Planning and Zoning Commission STAFF REPORT	Agenda # _____
---	--	----------------

TO: CASA GRANDE PLANNING AND ZONING COMMISSION
FROM: Jim Gagliardi, City Planner
MEETING DATE: October 2, 2014

- 1. DSA-14-00151 Housing Product** to add a new single-family model-type to the approved housing product within the Los Portales Planned Area Development, modifying approved Plan No. 155.2860 by expanding its square footage by 658 sq. ft. and proposing a new but comparable color palate to apply to one house on one lot.

Exhibit A

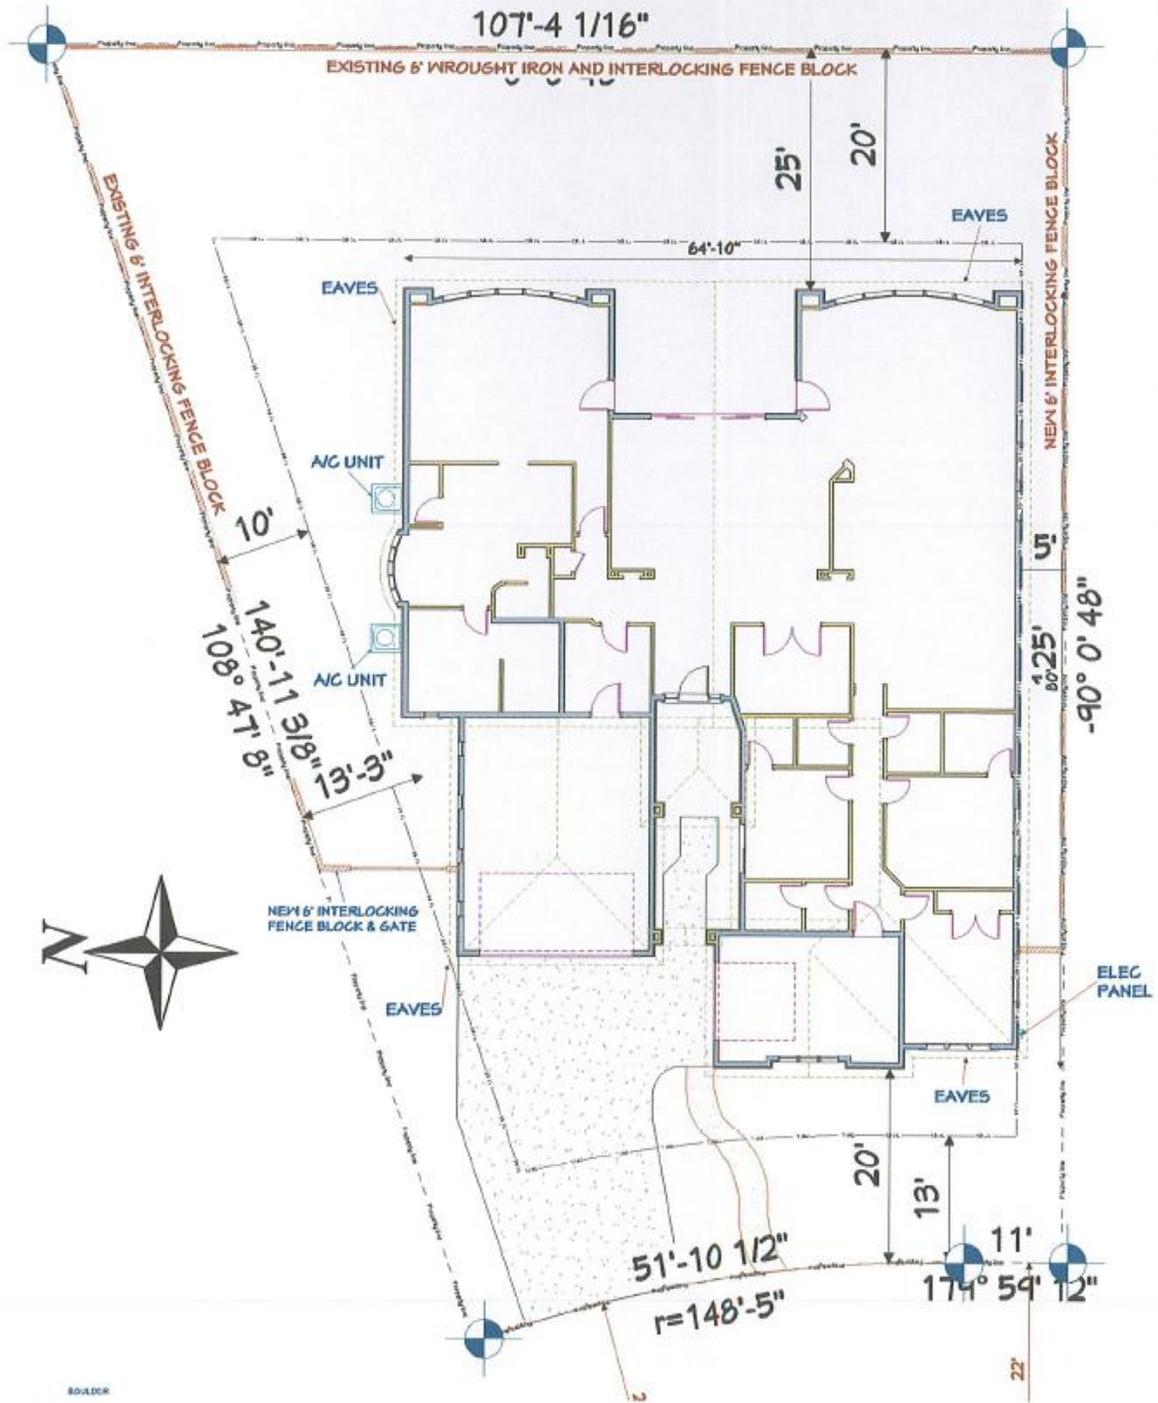
The new home product proposes stone veneer on the front elevation with a wood-grain garage door and steel gate offering further diversity and uniqueness within the PAD.

There is a covered front entry, recessed windows, and stone veneer along the base of the front elevation. The front door faces the street. As this plan is a modification of a previously approved plan, this elevation has already been assured to be compliant with this standard.

There is a recessed window in the front of the home, and all the other windows have stucco pop-outs. Since this plan is a modification from a previously approved plan, this criterion has already been addressed.

The layout of the home design allows for variations in roof ridge lines and design.

The proposed home will have 2 ground-mounted HVAC units.

There is a livable portion of the home that extends forward of the front-loaded garage.

There is livable area forward of the garage.

The front-loaded garage makes up less than 50% of the frontage of the house.

The home's rear patio is covered, as it's architecturally a part of the home.

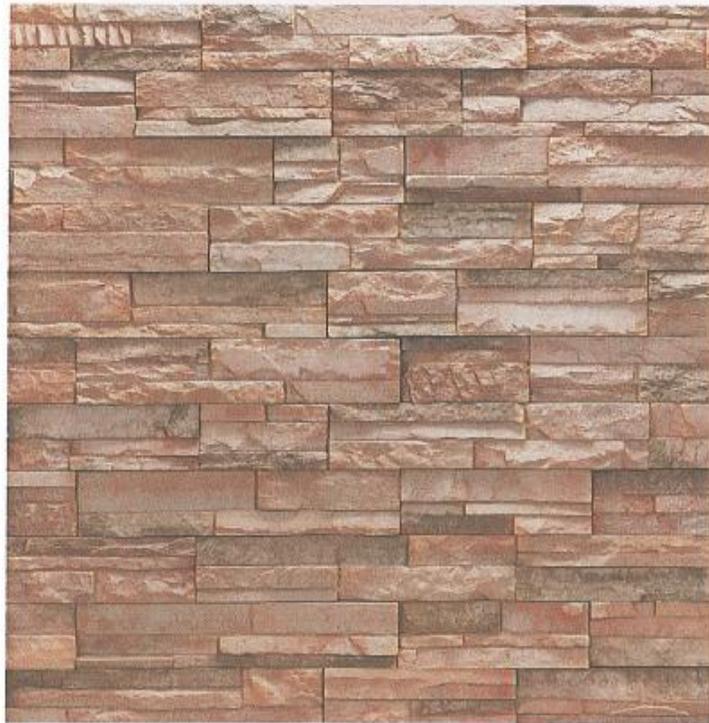
Twenty-seven color schemes have been previously approved for the PAD. The applicant proposes a twenty-eighth scheme, proposing brown and cream colors for the house. These colors are similar to other approved schemes, but vary slightly to match the owner’s preference and paint availability.

A terracotta red concrete tile roof type is chosen for this house. It is a muted hue and is compatible to other roof colors in the neighborhood.

The roof tile color was chosen to complement the color group for the exterior paint colors of the home. It is unique without clashing with other approved roof colors.
